3488 SAWMILL CRESCENT - " Parcel 16.1"  
(COMPLETE APPLICATION)  
DE418327 - ZONE CD-1

**DEVELOPMENT PERMIT STAFF COMMITTEE RECOMMENDATION: APPROVE**

THAT the Board APPROVE Development Application No. DE418327 submitted, the plans and information forming a part thereof, thereby permitting the development of a 5-storey mixed use building containing retail on the ground floor with 61 dwelling units over 2 levels of underground parking with vehicular access from the lane, subject to Council's approval of the Form of Development and the following conditions:

**DESIGN GRADES PLAN**  
SCALE 1:500

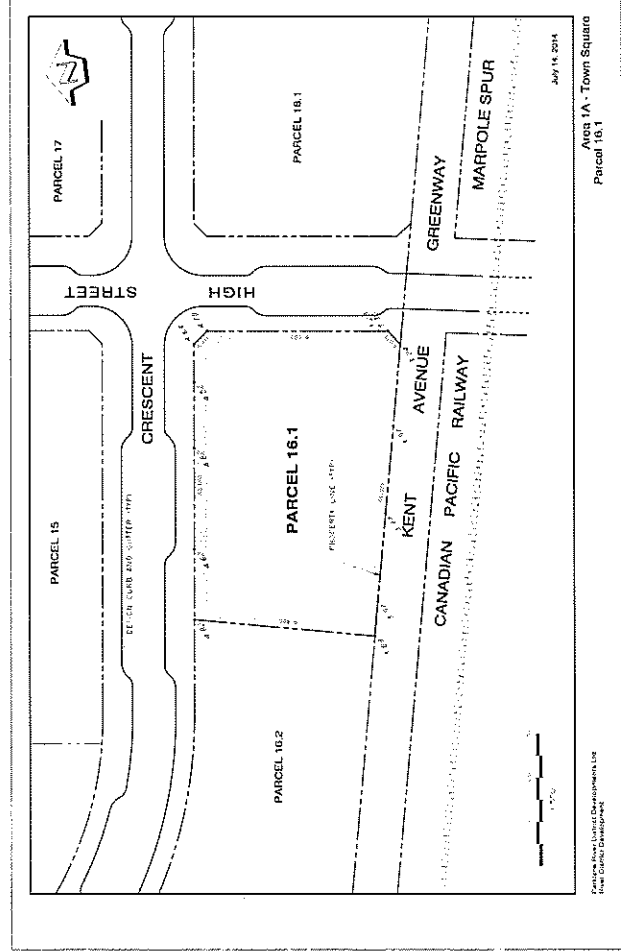
A.1.3 modifications to the height calculations and design grades as shown on drawing A1.0-H to coincide with the City building grades when they become available;

**Note to Applicant:** Provide a copy of the official City building grades plan. Elevations of the roof parapet are not consistent with the building elevations and site sections. Clarify the elevation of roof guardrail.

LOT 16.1 - DETAIL SECTIONS  
SCALE 1/4" = 1'-0"

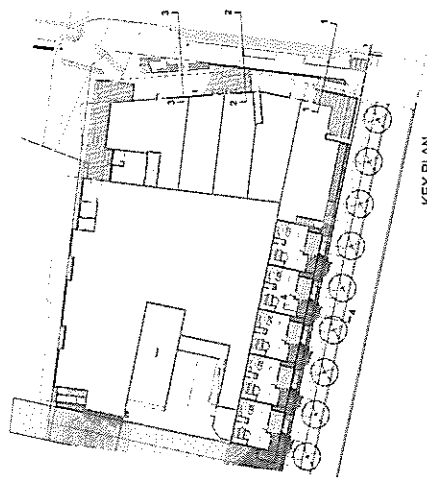
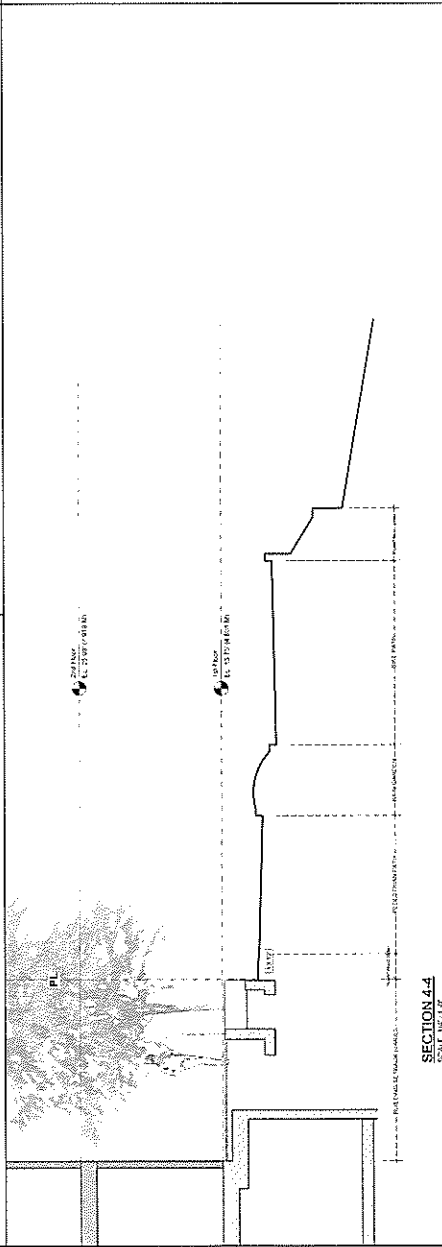
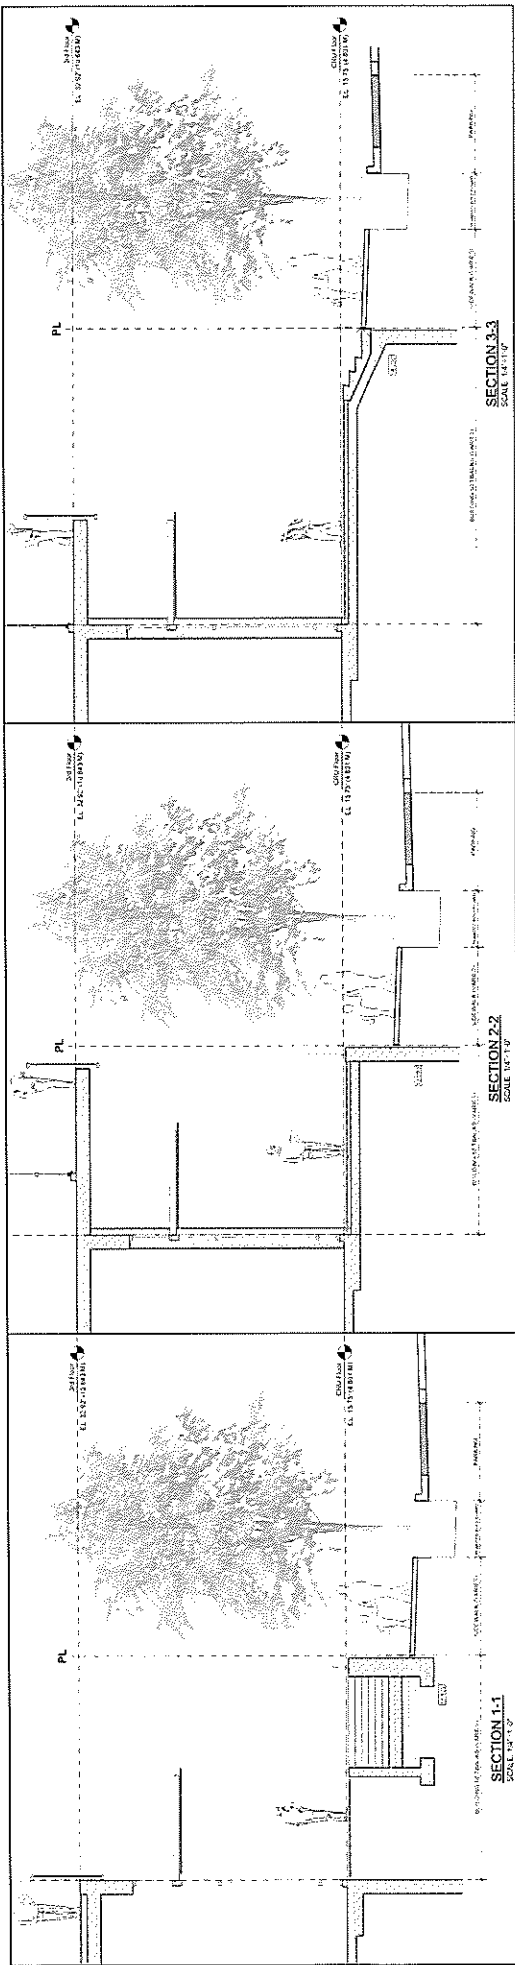
A.2.20 delete portions of footings shown on page A4.1 that encroach onto City street;
